From: [Uwkgg@aol.com](mailto:Uwkgg@aol.com)  
To: [Potala EIS](#); [Teresa Swan](#)  
Subject: Potala  
Date: Friday, August 24, 2012 5:00:19 PM

From: [Laura Loomis](#)  
 To: [Potala EIS](#); [Teresa Swan](#); [Joan McBride](#); [Doreen Marchione](#); [Penny Sweet](#); [Amy Walen](#); [Bob Sternoff](#); [Toby Nixon](#); [Dave Asher](#); [Mike Miller](#); [Jon Pascal](#); [Jay Arnold](#); [Andrew Held](#); [Byron Katsuyama](#); [Glenn Peterson](#); [C Ray Allshouse](#); [Kurt Triplett](#); [Robin Jenkinson](#); [Eric Shields](#); [Jeremy McMahan](#)  
 Subject: Potala EIS - Chap 3.1 Density Miscalculation and mischaracterization  
 Date: Saturday, August 11, 2012 1:26:47 PM  
 Attachments: [2012 EIS DENSITY.xls](#)  
[2012 Potala Chapter 3 1 with neighbor notations.pdf](#)

## 3.1 LAND USE

FIGURE 3.1-8 MULTIFAMILY DENSITIES

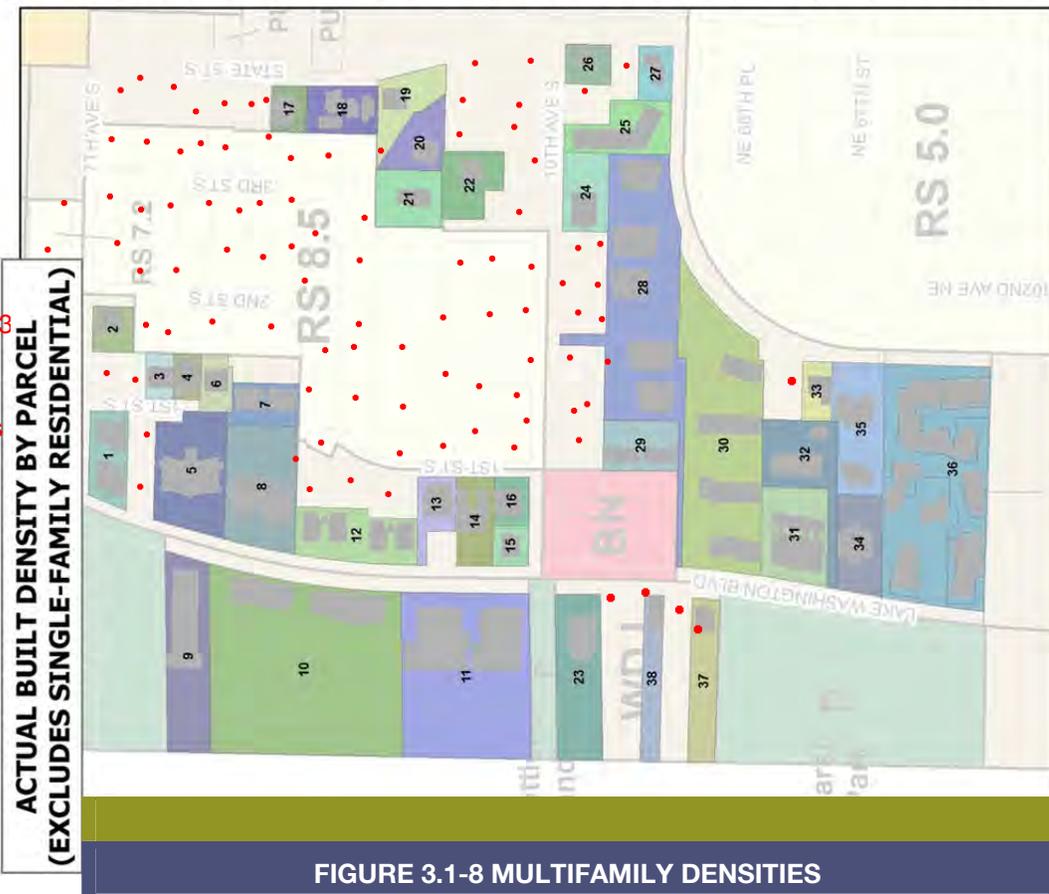
Source: City of Kirkland Zoning Code  
The study area ranges from 1-40 per acre with only 4 of 126 properties being greater than 24/ac. These 4 were built in 1968  
Why ignore single family homes?

5 Whole paragraph is garbage 15 miscalculations in the identified 38 properties 177/acre is actually 40/ac

3 Majority is not Multifamily! 2/3 of the bldgs are Single Family

Why exclude all the single family residential???

There are nearly 3 times as many singlefamily developments as multifamily buildings!!!

IMPORTANT: There are a total of 15 errors in these 38 density calculations. For example: #34 is my condo bldg and it has 9 units not 16. The density therefore is 18/acre not 32. The property size for #37 was incorrect. It is actually a density of 10/acre not 40. This leaves only 3 developments larger than 24/acre. #28 and #16 both built in 1968, and #9 was miscalculated with an incorrect site size. It was built at a density of 40/acre (NOT 177) over the water in 1969. This overwater is no longer allowed and, in general, the east side of LWB has different restrictions than the west side due to western properties being along the shoreline.

**FIGURE 3.1-9 STUDY AREA ZONING DESIGNATIONS**

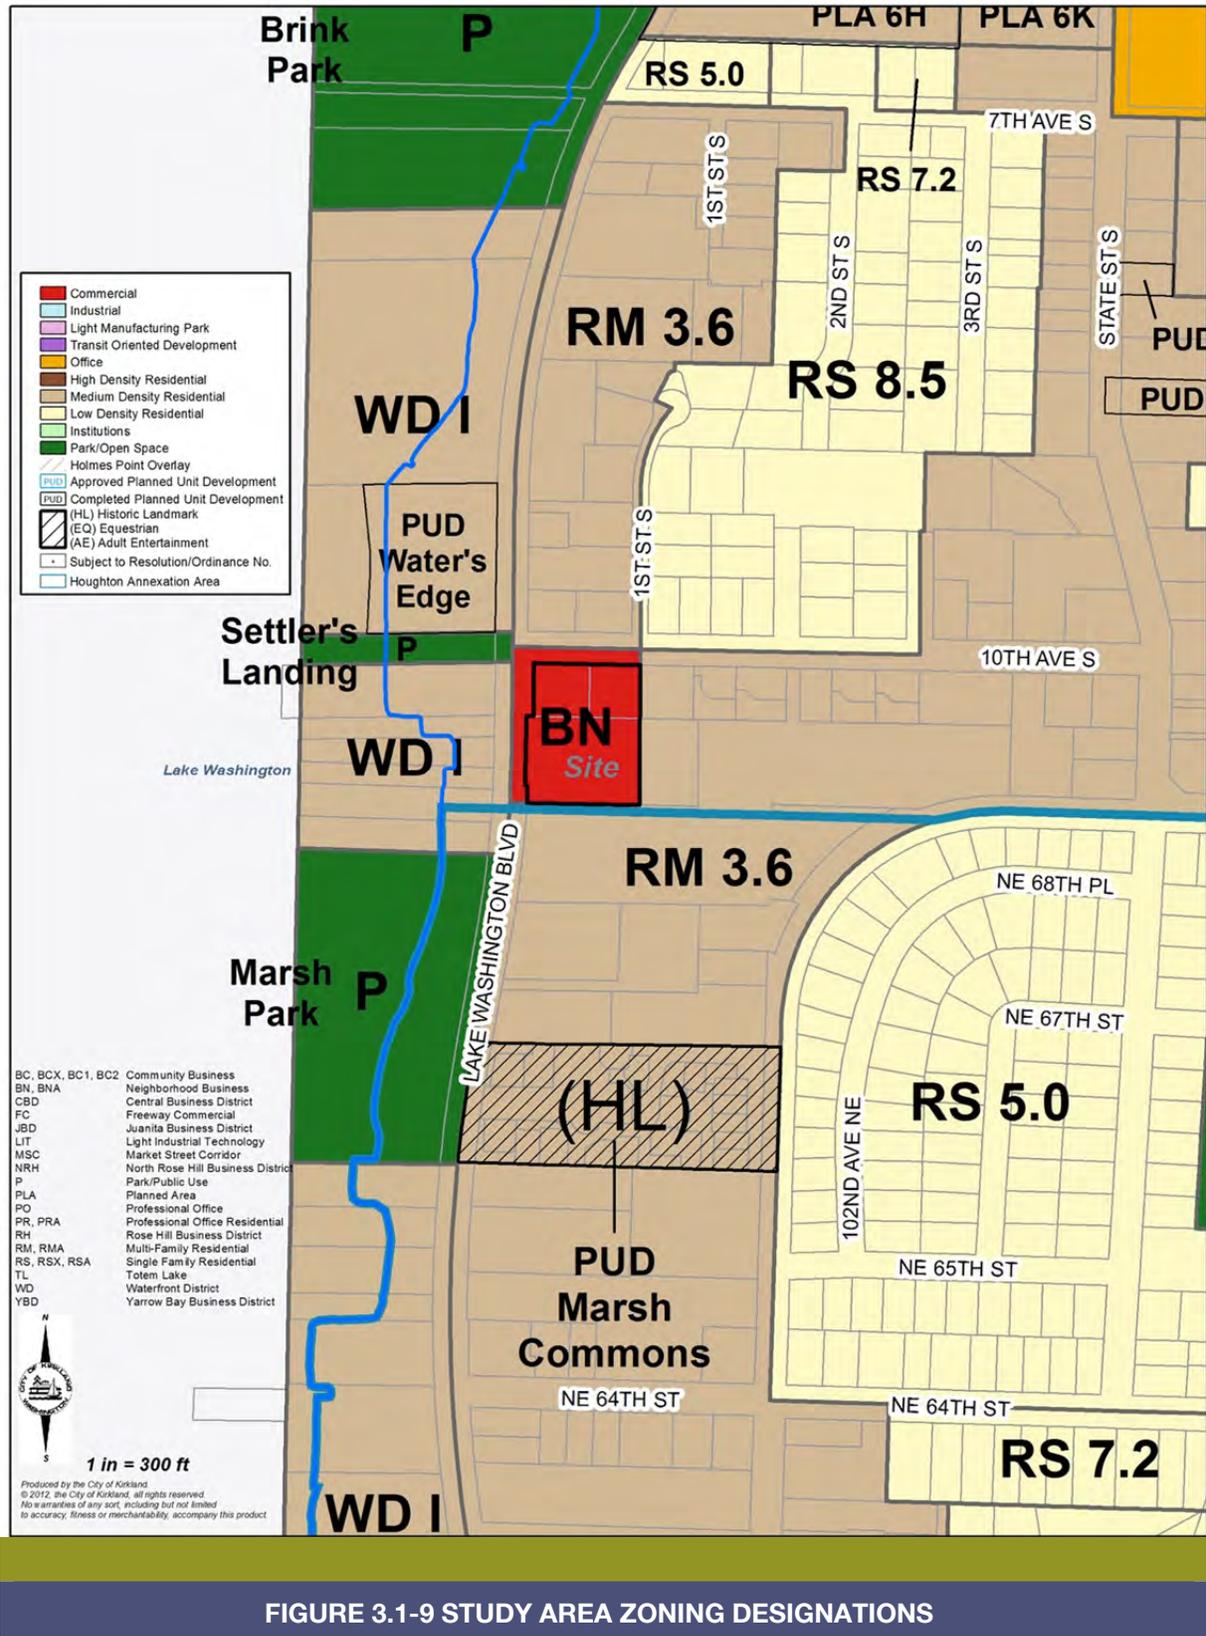
**RM 3.6 and WD 1 zones allow up to 12 units per acre and RS 8.5 allows 5 units per acre. All allow only 60% lot coverage and require significant property line set backs.**

**So how does 118/acre fit? How is 80% lot coverage similar or compatible... especially since it will be built across 3 lots unlike any other building in the area**
